AGENDA
PARKS, RECREATION & NATURAL RESOURCES COMMITTEE
MEETING

To: Planning Commission
From: Frank Dempsey, AICP, Associate Planner
Date: July 12, 2024
Subject: Packet Material for the July 18, 2024 Planning Commission Meeting

Ryan Sailer, representing Timberland Partners, Inc. has submitted applications and plans for a preliminary plat, final plat, and conditional use permit for Sundance Lakeville Second Addition, which proposes one lot and one block with 13 townhome buildings and 167 dwelling units and nine single family home lots with rental homes all totaling 15.75 acres north of 162nd Street (CSAH 46), west of Buck Hill Road and east of Kendale Avenue.

FOR REVIEW ONLY
PRELIMINARY
NOT FOR CONSTRUCTION

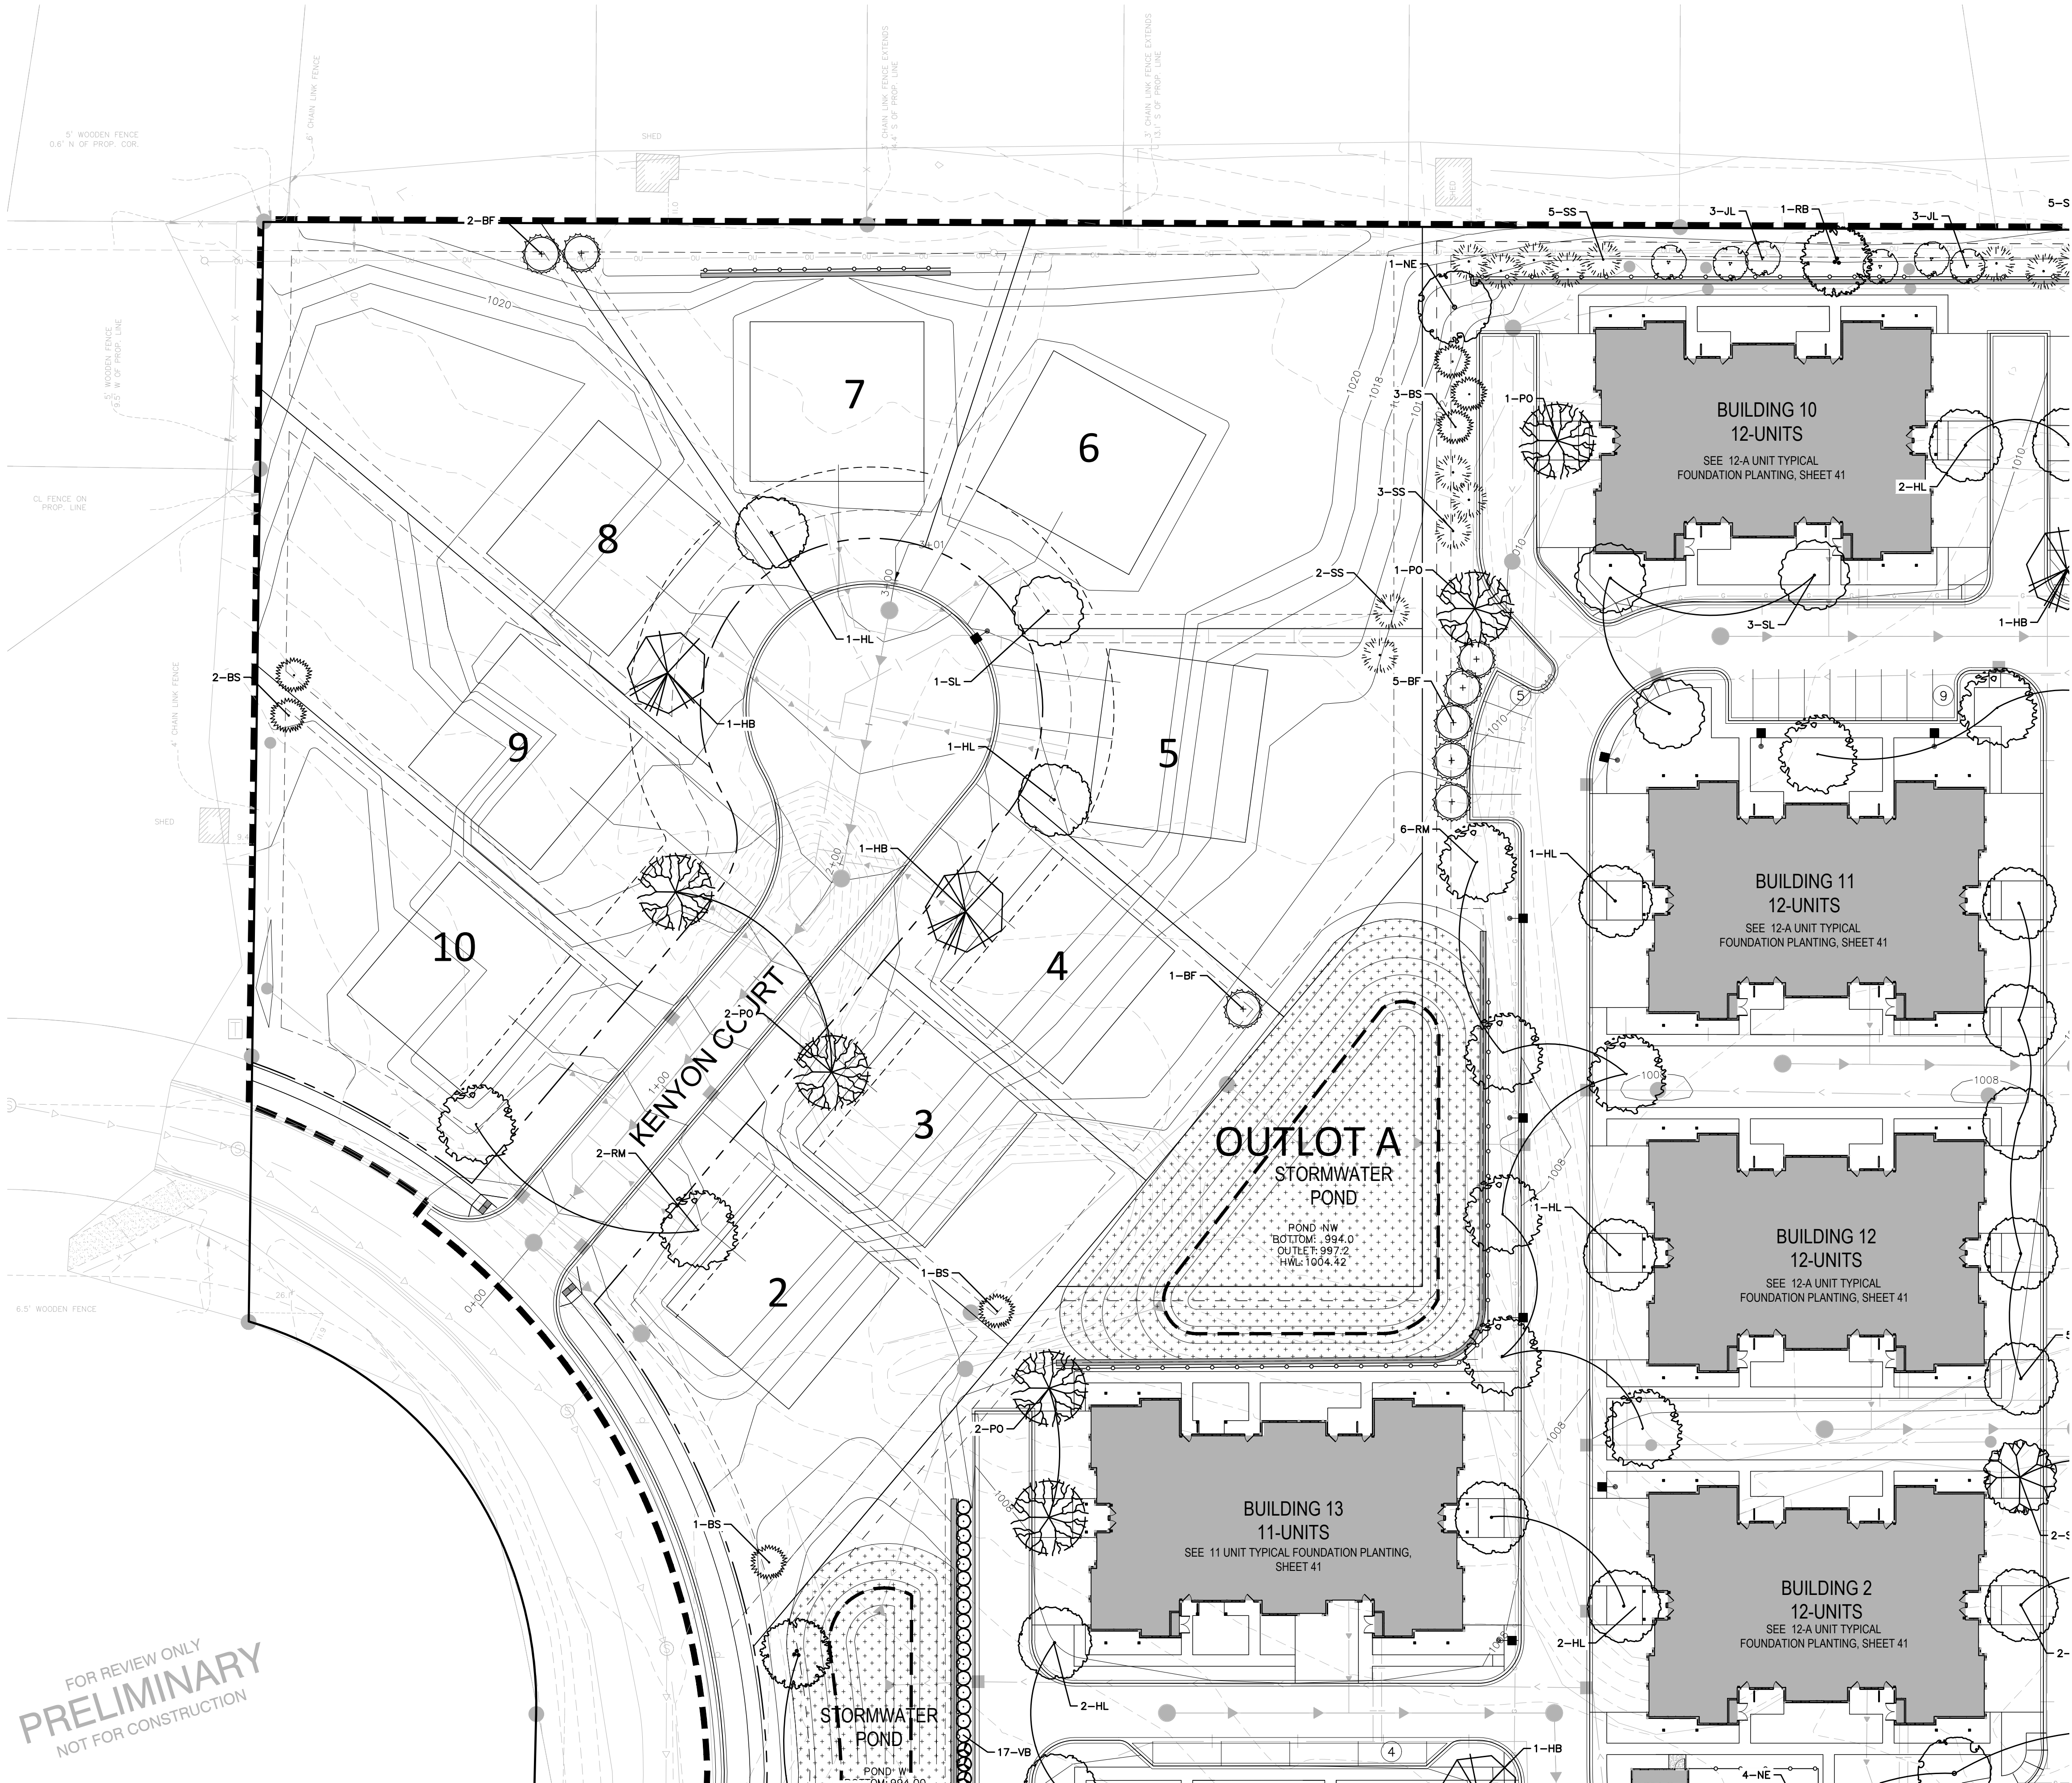
The site and landscape plan propose a minimum 30-foot landscaped buffer between the townhome property and the single-family homes to the north. A 30-foot landscaped buffer is consistent with the 30-foot required landscaped buffer between single family homes and commercial zoned property. The landscape plan design along the north boundary of Lot 1 shall be amended to include a row of evergreen trees planted south of the utility easement to provide additional year-round screening of the townhome buildings from the north.

3. Park dedication must be paid at the time of final plat approval.
4. The landscape plan design along the north boundary of Lot 1 shall be amended to include a row of evergreen trees planted south of the utility easement to provide additional year-round screening of the townhome buildings from the north.
